**US OIL RECOVERY SUPERFUND SITE
WORK PLAN REFINEMENT/MODIFICATION NOTICE**

WORKPLAN REFINEMENT/MODIFICATION NOTICE NO.: AOI-1-1

DATE: June 22, 2016

Figure 1

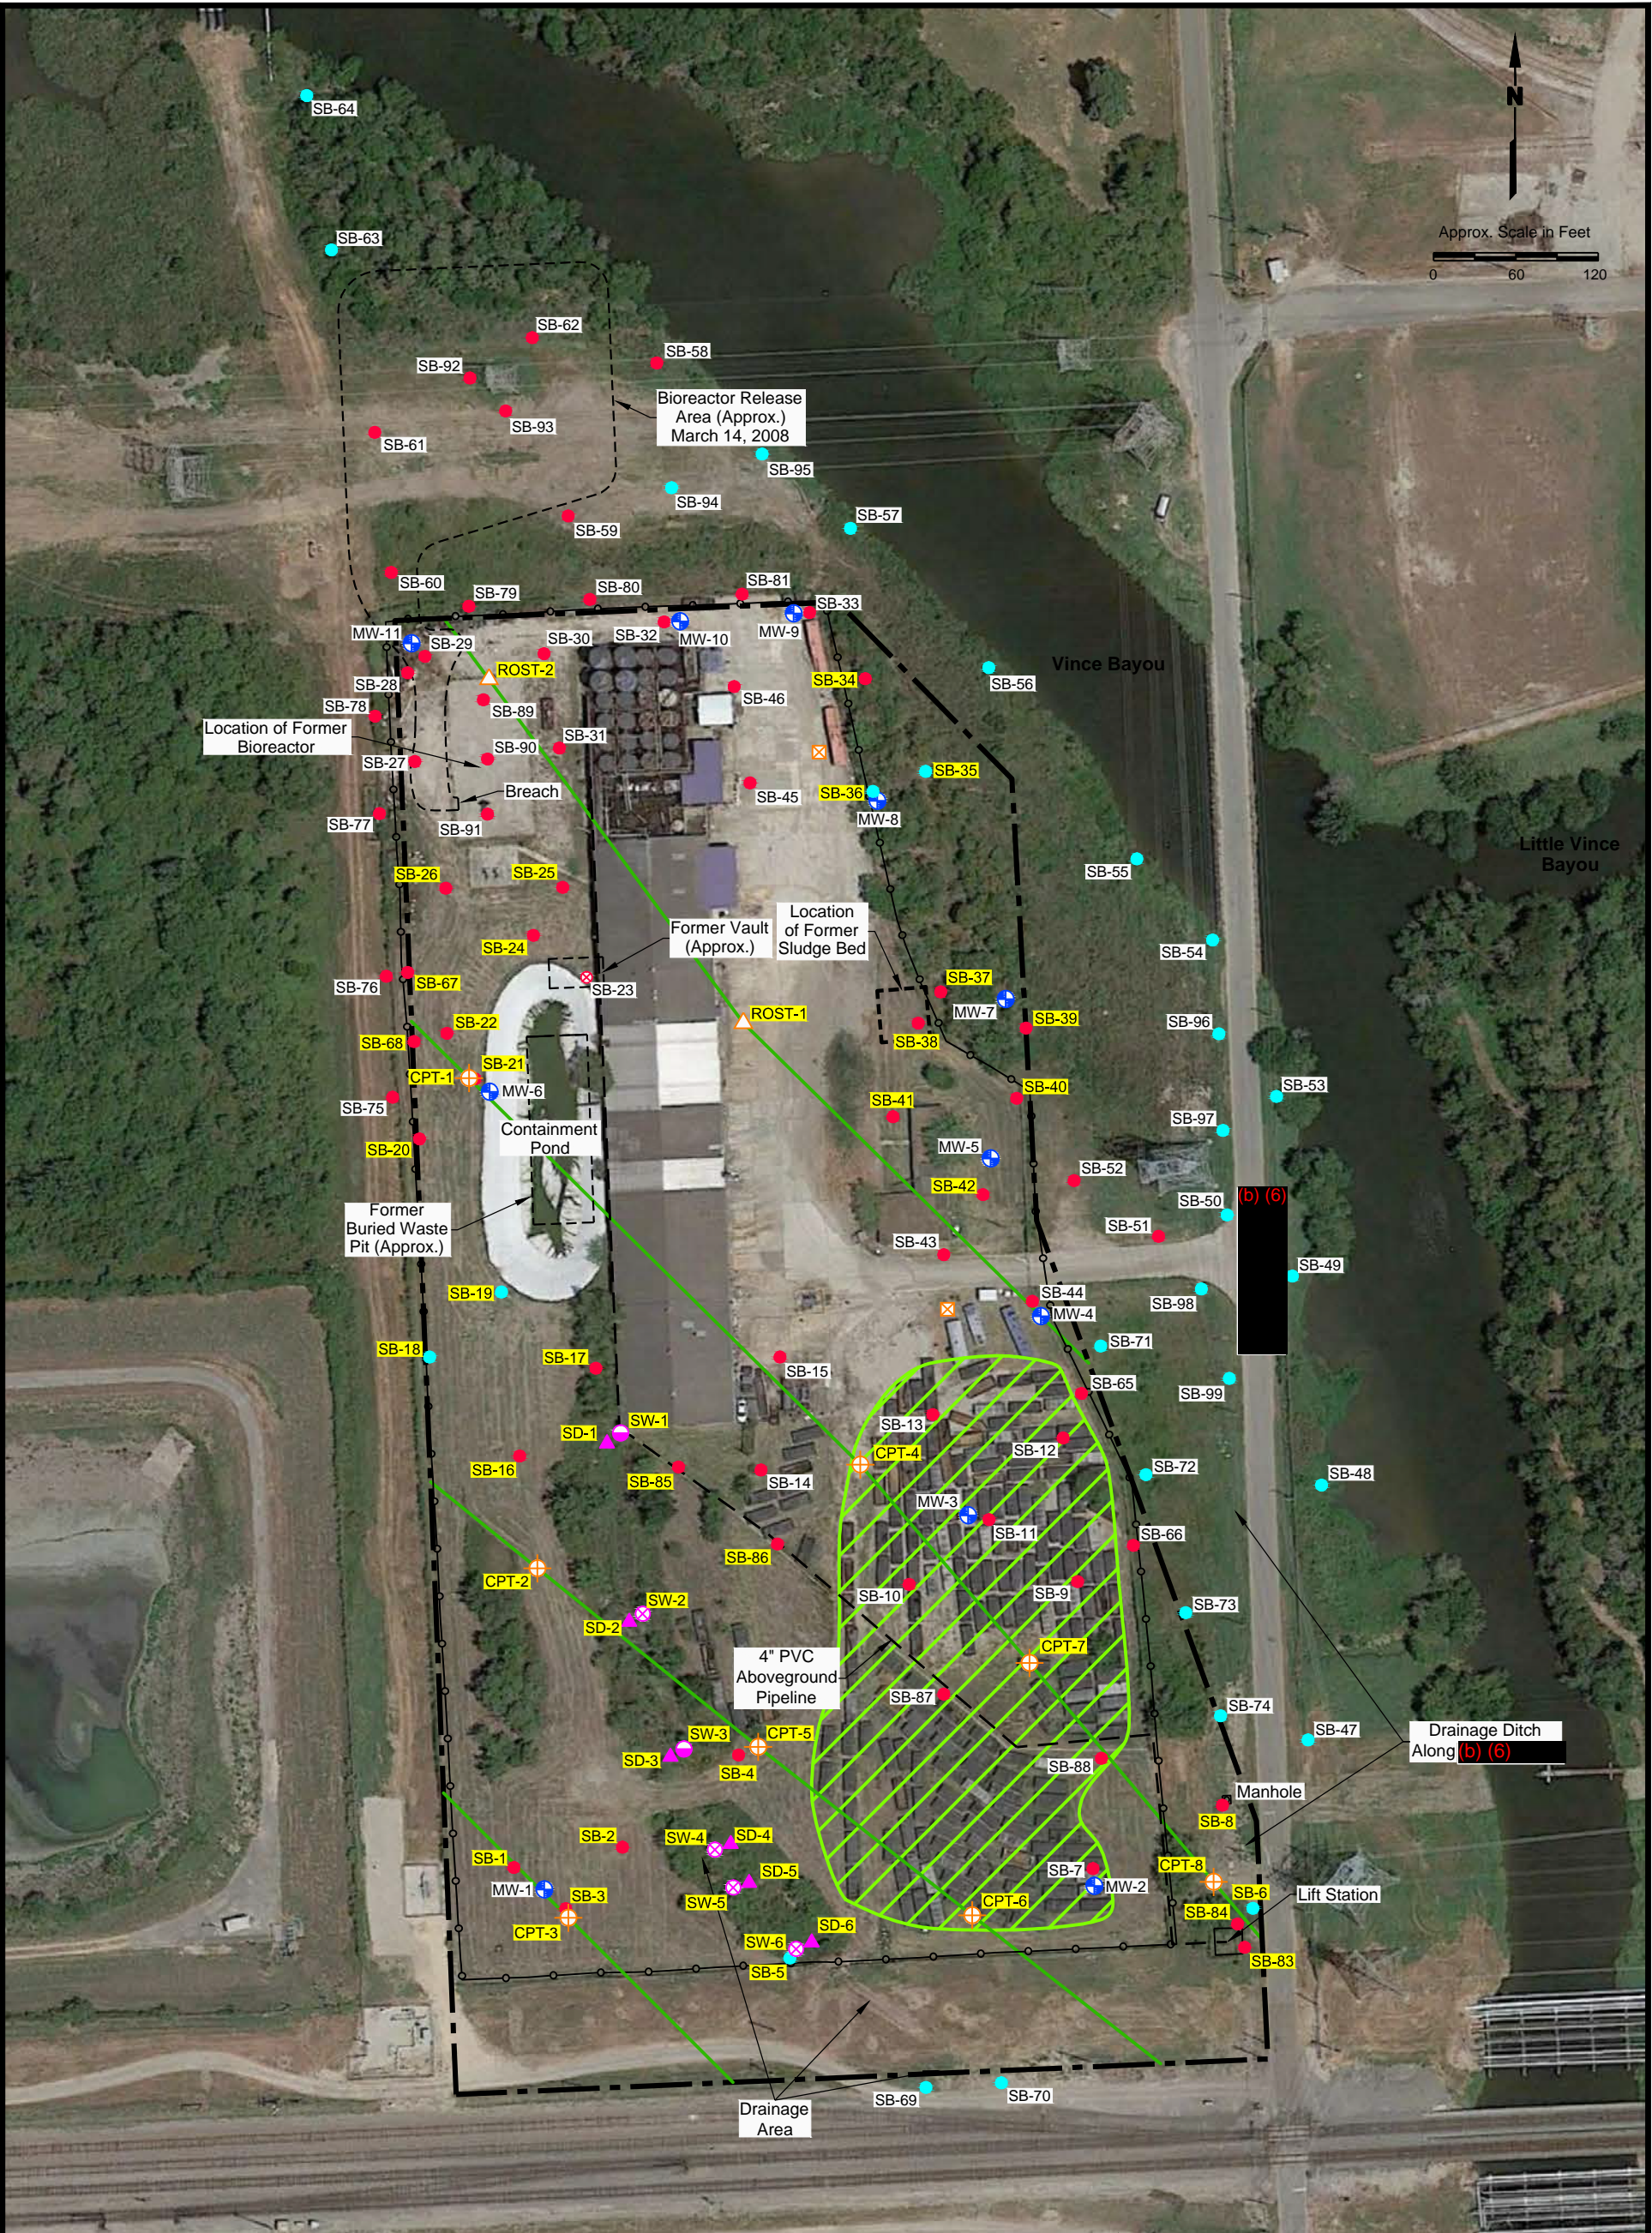
As requested by EPA, a revised sampling approach is proposed for eight soil borings located in the area where previously washed and emptied roll-off boxes had been staged. The roll-off boxes were transferred off-site during May and June, 2016. During the transfer, the area was rutted by heavy equipment used to load/move the roll-off boxes. Due to uneven ground and the tendency of the ruts to collect water, the ruts present a safety hazard and contribute to mosquito populations at the site. To ensure the safety of personnel and equipment accessing the area, the approximate area shown on Figure 1 in Attachment A was regraded using a trackhoe bucket after the roll-off boxes had been removed. Eight proposed soil borings are located within the regraded area (SB-7, SB-9, SB-10, SB-11, SB-12, SB-13, SB-87 and SB-88). To account for surface soil disturbance as a result of regrading activities, EPA proposed additional shallow soil samples for these eight borings located within the regraded area. The additional shallow soil samples will be collected at each boring from 0.5-1.0, 1.0-1.5 and 1.5-2.0 feet below ground surface (bgs).

The remaining soil samples in each boring within the regraded area will be collected in accordance with the RI/FS Work Plan and the Field Sampling Plan. (i.e., a sample from 0-0.5 feet, a sample between 2.0 feet and 5.0 feet, and a sample below 5.0 feet above the water table). All samples collected from borings not located within the regraded area will be collected in accordance with the RI/FS Work Plan and the Field Sampling Plan.

To account for surface soil disturbance resulting from regrading activities in the former roll-off box storage area, additional shallow soil samples will be collected to evaluate COPC concentrations within the disturbed soils.
